Subject: AP1000 COL Response to Requests for Additional Information (TR #37)

In support of Combined License application pre-application activities, Westinghouse is submitting a response to the NRC request for additional information (RAI) on AP1000 Standard Combined License Technical Report 37, APP-GW-GLN-003, Hydrogen Igniter Locations. This RAI response is submitted as part of the NuStart Bellefonte COL Project (NRC Project Number 740). The information included in the response is generic and is expected to apply to all COL applications referencing the AP1000 Design Certification.

RAI-TR37-001

Title: Hydrogen Igniter Locations

Figure 6.2.4-5

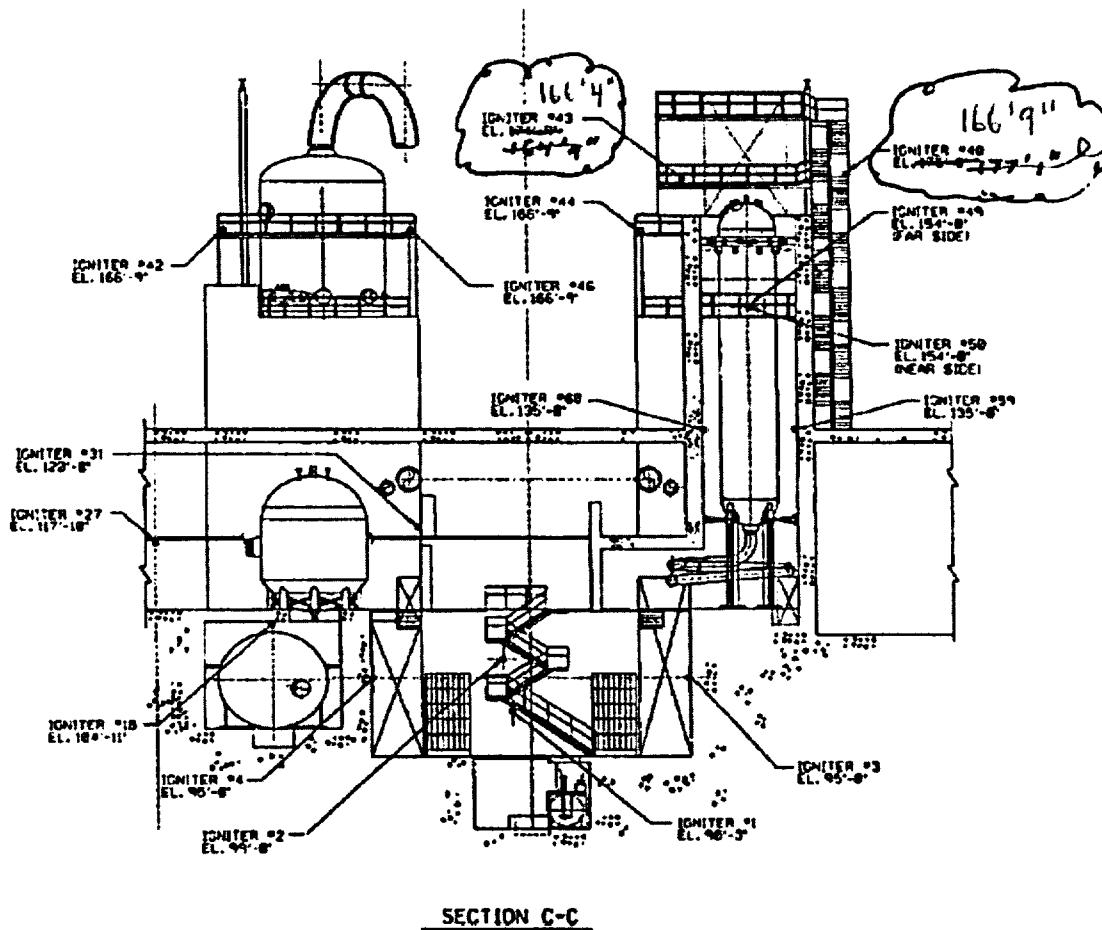
c) Section III, DCD Mark-Up, of TR37 will be updated to reflect the latest igniter #40 and #43 elevation changes identified in TR36 for DCD Figures 6.2.4-5, 6.2.4-11, and 6.2.4-13 that were superseded by TR36 changes. The igniter elevation changes in these three TR36 figures were approved and submitted to the NRC after TR37 was submitted, so they correctly supersede the TR37 version of these figures.

(TR 36 also identified that there was an inconsistency in the original elevation of igniter #40 in DCD Figure 6.2.4-5 that was shown to be 175'8" while the correct original elevation was shown in DCD Figure 6.2.4-11. This inconsistency was corrected but not discussed in the original TR37 markups and is also corrected in the revised TR37 markups for this RAI response.)

The TR37 changes for Figures 6.2.4-5, 6.2.4-11, and 6.2.4-13 should NOT be incorporated into the DCD. The TR37 changes for these figures are superseded by changes in TR36 but TR36 includes additional changes beyond those in TR37. The TR36 changes are reflected in TR37 for completeness.

Revise Figure 6.2.4-5 as follows:

Figure 6.2.4-12

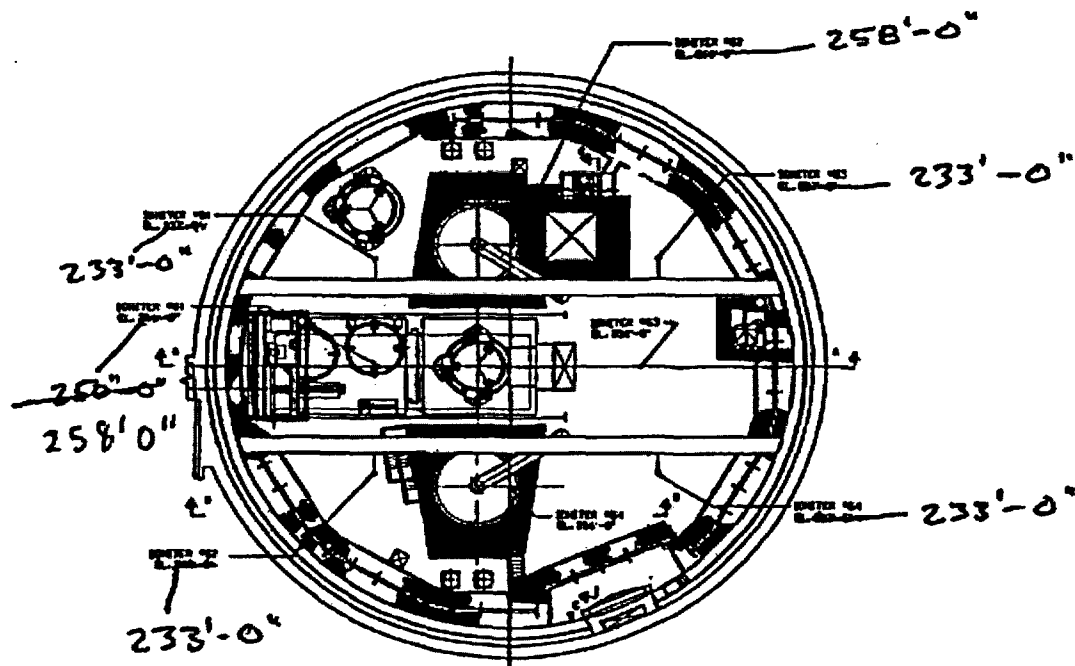
d) The markup for Figure 6.2.4-12 for TR37 incorrectly revised the elevation for igniter #61 to 250'0" instead of 258'0" which was inconsistent with TR37 markup for Figure 6.2.4-13. The corrected markup for Figure 6.2.4-12 is provided to reflect 258'0".

Figure 6.2.4-12 Revise Figure 6.2.4-12 as follows:
